Interactive comment on “The arctic seasonal cycle of total column CO₂ and CH₄ from ground-based solar and lunar FTIR absorption spectrometry” by Matthias Buschmann et al.

Received and published: 5 May 2017

Interactive comment on Atmos. Meas. Tech. Discuss., doi:10.5194/amt-2017-40, 2017.

Fig. 1. The SNR improvement of a Bruker 125 HR as a function of resolution for a integration time of 5 minutes.

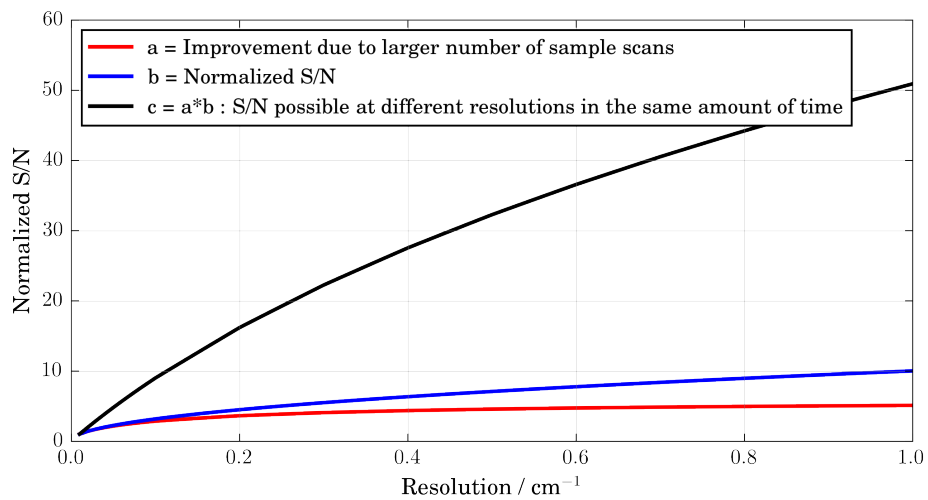
Page 7, line 10 ff: “. . .one option to decrease measurement time . . . is to increase the velocity . . .”. No, this is not the case in the context of optimizing the spectral signal-to-noise-ratio (SNR). Here, only the spectral resolution and the throughput matter. I would have expected (for a given allowed integration time) to see a more pronounced reduction of error bars on the retrieved columns until a further reduction of resolution

starts to decrease the contrast between the lines and the adjacent continuum. Has the spectral SNR been adjusted as function of resolution in this manner (assumption of a certain amount of available integration time)? When comparing different resolutions, one might also take into account that a larger fieldstop can be applied when resolution is reduced (increasing the signal level, favoring shorter scans even more).

While the increase in velocity does increase the number of scans possible in the same time frame, this has no effect on the spectral S/N. The wording will be adjusted to clarify. Assuming the second comment refers to Figure 6, no, the data set has not been adjusted for the possible number of spectra within a certain time frame. The aim was to understand what impact the spectral noise has as a function of resolution on the retrieval. A figure highlighting the increase in signal-to-noise ratio (SNR) is included below in Figure 1 and will be integrated in the revised manuscript together with the following explanation: Here the increase in SNR was measured as a function of spectral resolution with a Bruker 125 HR, normalized to the SNR at 0.02 cm⁻¹, i.e. a spectrum recorded with 1.0 cm⁻¹ resolution has a 10 times larger SNR (see blue line). Additionally, the shorter scan length allows to record more spectra in the same time frame. Averaging leads to an increase in SNR by a \sqrt{N} with N measurements (red line). The resulting black line shows the potential increase in SNR with resolution for a fixed integration time. At lower resolutions the size of the entrance aperture is limited by the size of the image of the lunar disk, rather than the resolution.

Figure and discussion will be added to Section 3.4 of the final manuscript.
